Frequently Asked Questions

**Project: Bayshore Boulevard Safety and Multi-Modal S&PM Improvements
(from W Hawthorne Road to W Platt Street, northbound lanes)
(from S Howard Avenue to W Platt Street, southbound lanes)**

This document addresses questions and comments regarding the proposed City of Tampa Bayshore Boulevard Signing and Pavement Markings Project. Attached are responses to frequently asked questions (FAQ) and comments which were raised during and after the February 23, 2017 public meeting for the project.

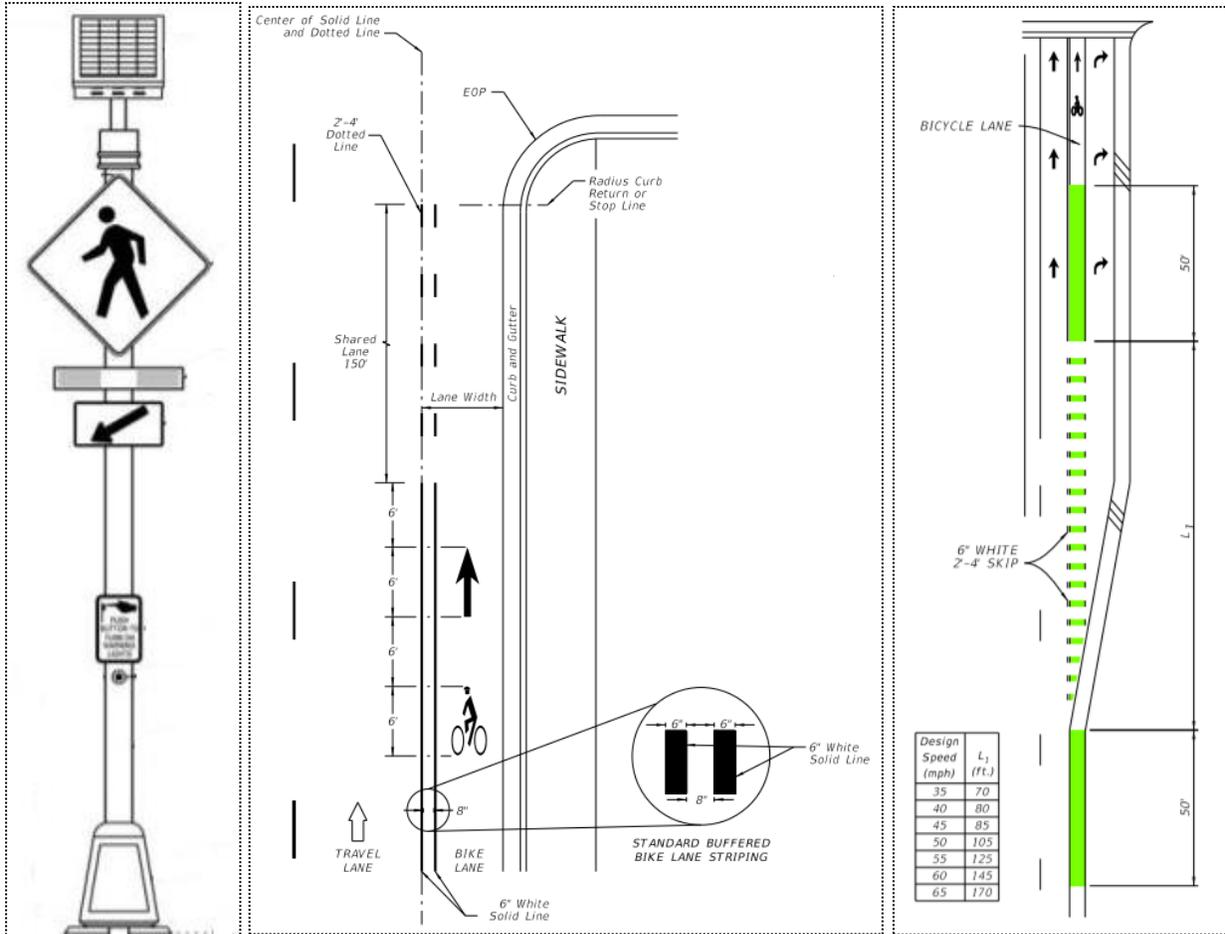
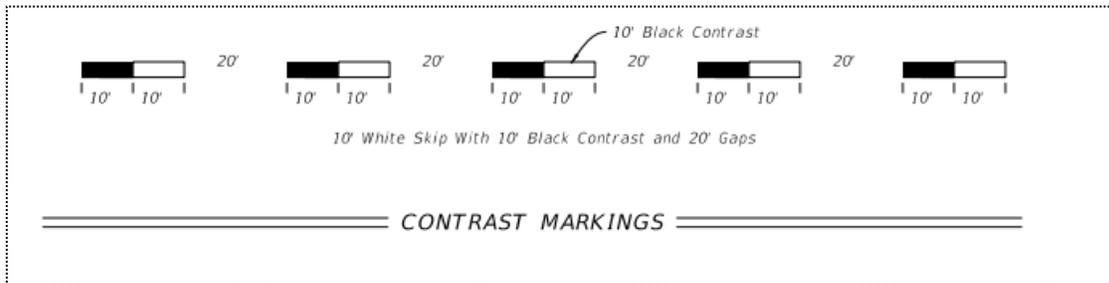
Question 1 – Why is the City doing this project?

The intent of this project is to implement low-cost improvements that can provide a safer and more equitable balance among the transportation modes and be more compatible with adjacent land use activities within the corridor. Rather than just replace the existing striping, the City plans to implement new standards that have been developed since the previous pavement markings were installed that can have a transformative impact on the corridor for all users (See examples under Figures 1-1 through 1-4).

The proposed improvements include:

- Replacing faded striping between Rome Avenue and Platt Street, with new striping including black contrast in the skip lines and pavement message markings;
- Adding a 2-ft buffer to the existing bicycle lanes;
- Reducing width of travel lanes to 10 feet;
- Providing green pavement markings at the right-turn lane conflict point at De Soto Avenue;
- Installing Rectangular Rapid Flashing Beacon's (RRFB) at several crosswalk locations to improve pedestrian safety and encourage vehicular compliance, including:
 - S. Dakota Avenue,
 - S. Delaware Avenue, and
 - between S. Brevard Avenue and W. Swann Avenue; and,
- Reducing the posted speed limit from 40 MPH to 35 MPH and to increase safety by reducing the number and severity of crashes.
